UNITED STATES PATENT AND TRADEMARK OFFICE

10/587,145

Office Action Summary	Application No. 10/587,145	Applicant(s) KOERBER ET AL.	
	Examiner ELIZABETH VOLZ	Art Unit 3781

DETAILED ACTION

Figure 1 (Reutter)

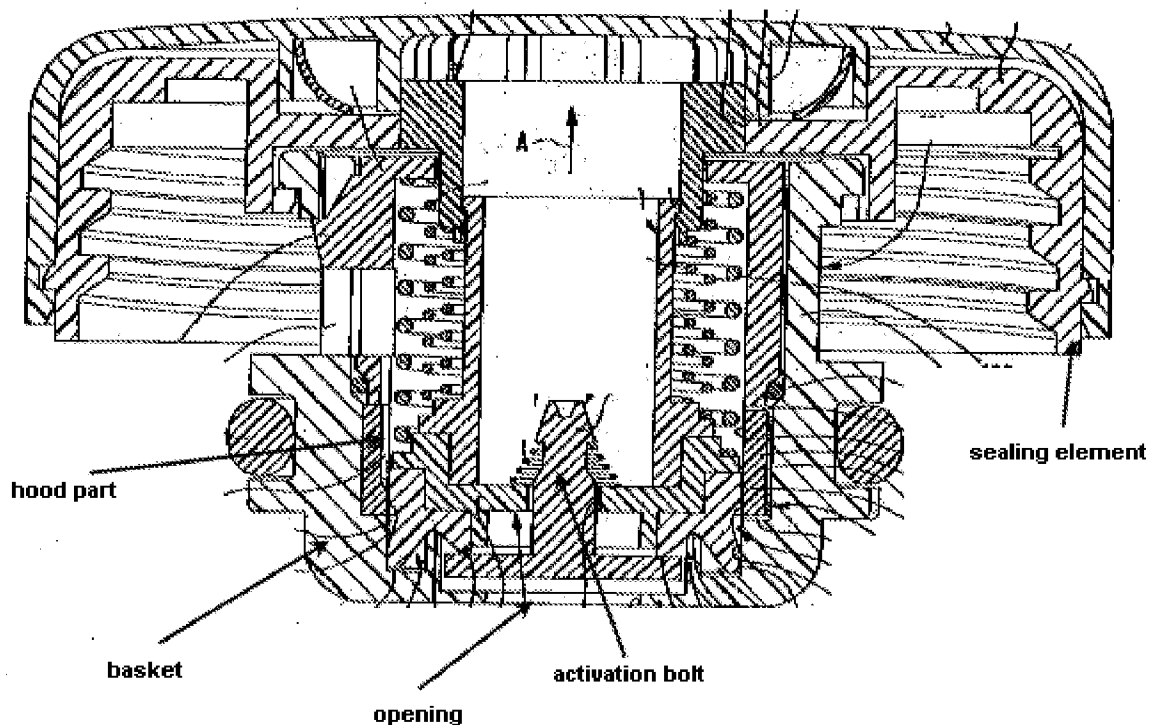
8. Claims 18-27 and 29-34 are rejected under 35 U.S.C. 102(b) as being anticipated by Reutter (U.S. Pub. No. 2003/0183632).
9. Regarding Claim 18, Reutter discloses an anti-twist device for a sealing cap, mountable or mounted on a fixed connecting piece of a container, in particular a motor

vehicle radiator (Paragraph 19), said sealing cap having: an external cap part 110 (Figure 1) with a grip element 112 (Figure 1) and with a sealing element (Figure 1 below) that is connectable to a counterpart sealing element of the connecting piece (Figure 1 below), relative to which sealing element said grip element is kept relatively rotatable; an internal cap part 114 (Figure 1) with a valve assembly 115 (Figure 1) embodied preferably as an excess/negative pressure combination; an anti-twist stop 180 (Figure 1) and in the external cap part which acts between said grip element and said sealing element; and a drive 171 (Figure 1) triggered by the operating data in the container, the drive being accommodated inside the container near the external cap part and serving to actuate said anti-twist stop (Figure 1).

10. Regarding Claim 19, Reutter discloses a drive has a drive part 172 (Figure 1), disposed on a circumferential region of a container wall adjacent to the connecting piece (Figure 1).

11. Regarding Claim 20, Reutter discloses a drive which is formed by two or more drive parts, distributed preferably uniformly over the circumference of a container wall adjacent to said fixed connecting piece (Figure 1).

12. Regarding Claim 21, Reutter discloses each of two drive parts is disposed, held separately, inside the container and tangentially below said counterpart sealing element of the connecting piece (Figure 1).

13. Regarding Claim 22, Reutter discloses each drive part is received in a housing (Figure 1 above) that is held suspended from the container wall.

14. Regarding Claim 23, Reutter discloses said housing is held in pressure tight fashion in a recess in the container wall (Figure 1).

15. Regarding Claim 24, Reutter discloses said housing is composed of a hood part (Figure 1 above), protruding from the container wall, and a basket part (Figure 1 above), whose bottom is provided with an opening (Figure 1 above).

16. Regarding Claim 25, Reutter discloses a hood part (Figure 1 above) which is provided with an axial lead through, which penetrates the container wall and is held in it in pressure tight fashion (Figure 1).

17. Regarding Claim 26, Reutter discloses a hood part and said basket part are joined, locking over and in one another (Figure 1).

18. Regarding Claim 27, Reutter discloses each drive part has a vertically oriented actuation bolt (Figure 1 above), which, facing toward said anti-twist stop, penetrates the container wall (Figure 1).

19. Regarding Claim 29, Reutter discloses a drive part which is pressure-controlled, and its actuation bolt is spring-loaded 167 (Figure 1) in the opposite direction.

20. Regarding Claim 30, Reutter discloses an anti-twist stop 180 (Figure 1) which has a horizontally disposed and axially movable coupling unit (Figure 1).

21. Regarding Claim 31, Reutter discloses a coupling unit has a number of separate coupling elements, corresponding to the number of drive parts, which coupling elements are each diametrically opposite said drive part or drive parts (Figure 1).

22. Regarding Claim 32, Reutter discloses a coupling element which is joined in a manner fixed against relative motion to an axial bolt 147 (Figure 1), which can be acted upon by said actuation bolt counter to the action of a compression spring 183 (Figure 1).

24. Regarding Claim 34, Reutter discloses a unit comprising a container having one of: a connecting piece, and a container connecting piece (Paragraph 19) and a sealing cap 111 (Figure 1), having an anti-twist device 180 (Figure 1; Paragraph 19), said

sealing cap having: an external cap part 110 (Figure 1) with a grip element 112 (Figure 1) and with a sealing element (Figure 1 above) that is connectable to a counterpart sealing element of the connecting piece (Figure 1), relative to which sealing element said grip element is kept relatively rotatable; an internal cap part 114 (Figure 1) with a valve assembly 115 (Figure 1) embodied preferably as an excess/negative pressure combination; an anti-twist stop 180 (Figure 1) and in the external cap part which acts between said grip element and said sealing element; and a drive 171 (Figure 1) triggered by the operating data in the container, the drive being accommodated inside the container near the external cap part and serving to actuate said anti-twist stop (Figure 1).
